DEPARTMENT OF MINES
SOUTH AUSTRALIA

REPORT ON DRAINAGE PROSPECTS

PT. SEC. 521. HD. NOARLUNGA

- Town Planner - re Olson, Mattiazzo, & Agostinetto -

Approved	Passed	Drn.	UNDERGROUND WATER SURVEY HP NOARLUNGA PT SEC. 521 HAPPY VALLEY SUBDIVISION FOR TOWN PLANNER.	D.M.	Scale 40 Chns. to 1"
		Tcd. B.G.		Req.	S 3050
		Ckd. R.R.			Ho 2
Director		Exd.			Date 1-3-62

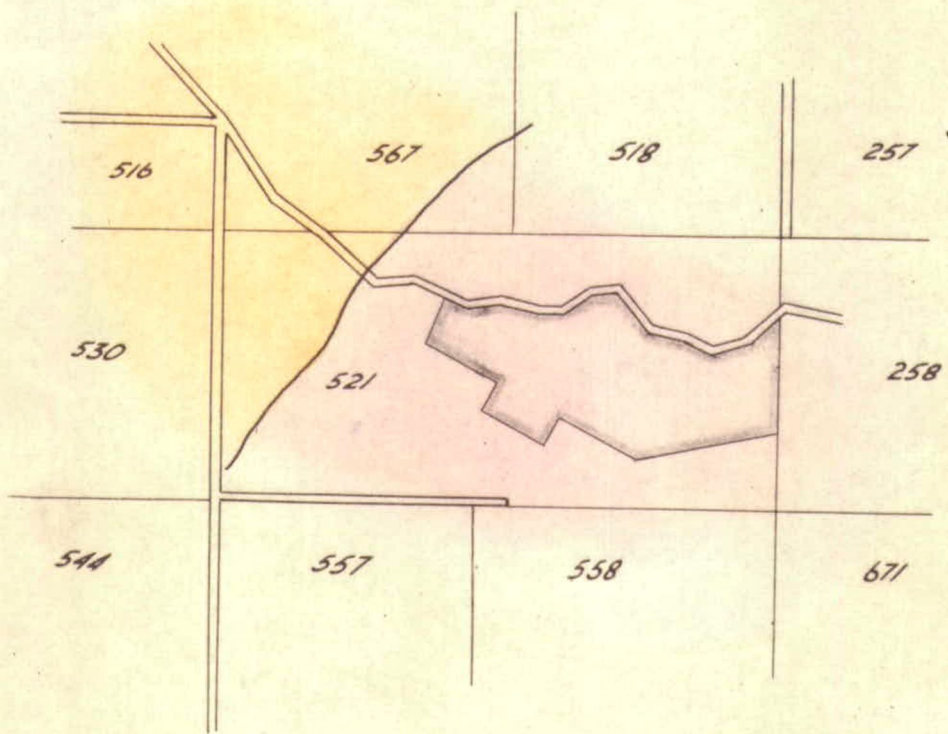
In several instances blocks can be expected to be seriously affected by soakage from upslope, and I believe this will be the case in allotments 33, 35, 54, 55 and probably 56. Allotment 21 will also be in trouble unless adequate steps are taken to divert drainage from Allotment 20 upslope, and run it out on to the road.

Water from View Court road pavement is being drained through a pipe onto Allotments 21 and 22, and a drainage easement downslope between these two allotments will be needed, with a properly constructed discharge pipe or lined channel.

Subsurface drainage is poor. Trouble may occur in two areas, being Allotments 30-38 and 54-59, and it is suggested that Allotments 33, 35, 54, 55 and probably 56 should be deleted. Conditions in the other parts of these areas may not be bad enough to warrant such a recommendation.

A drainage channel between Allotments 21 and 22 is also needed.
